Permit
SEWAGE SYSTEM REPAIR

Establishment
LOREN KUZELKA
T10N R6E SEC 10
4201 N 1 STREET

FORM HD-41(73) APPLICATION FOR PERMIT TO ALTER, EXTEND OR REPAIR INDIVIDUAL SEWAGE DISPOSAL SYSTEM

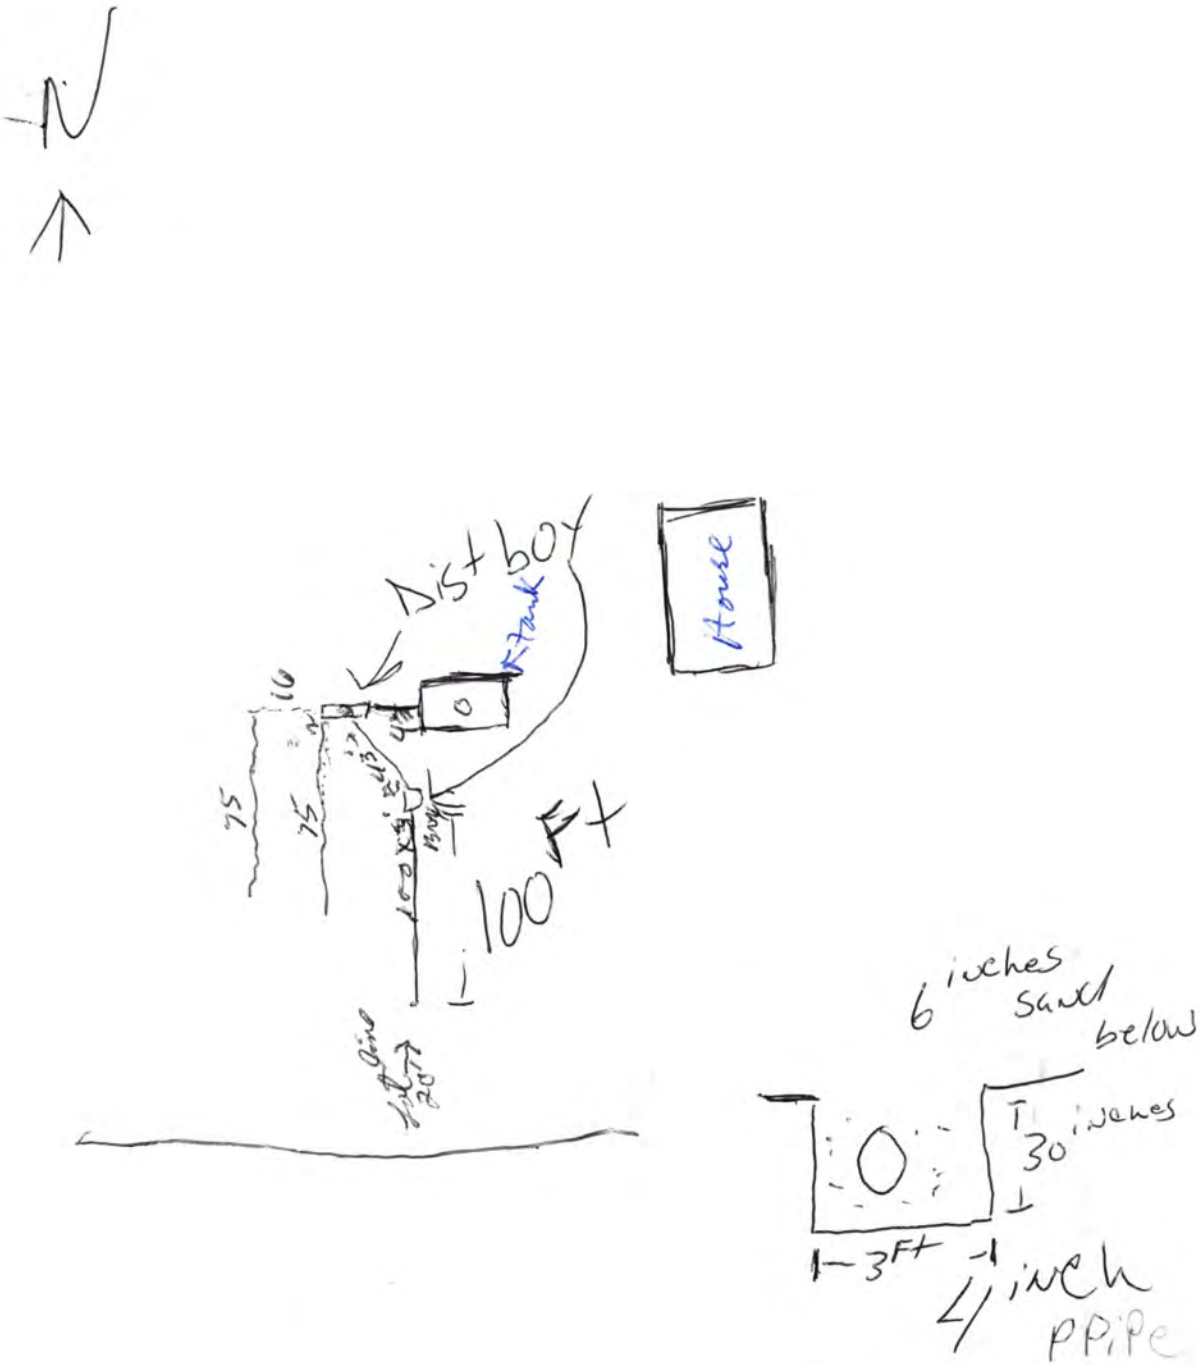
* Extra 100 ft of soil surface lateral would be a better way to extend the life of the septic system.
